Company	Trenz Electronic GmbH
PCN Number	PCN-20240705
Title	TE0703-07 Assembly pull-down resistor R36.
Subject	Assembly pull-down resistor R36.
Issue Date	2024-07-22

2.1 #1 Assembly pull-down resistor (R36).

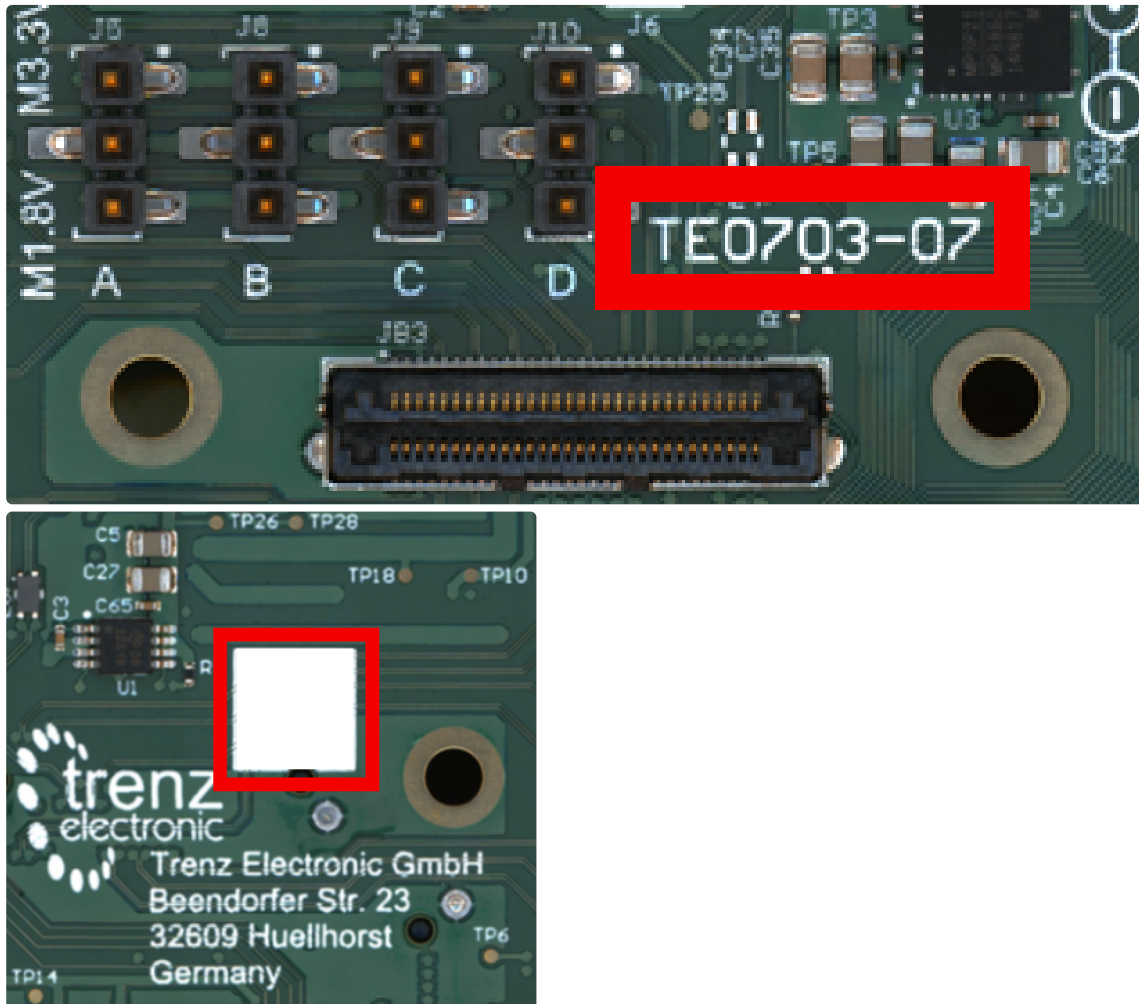
Type: BOM Change

Reason: Do not allow floating signal "OTG_ID" for host only applications.

Impact: None.
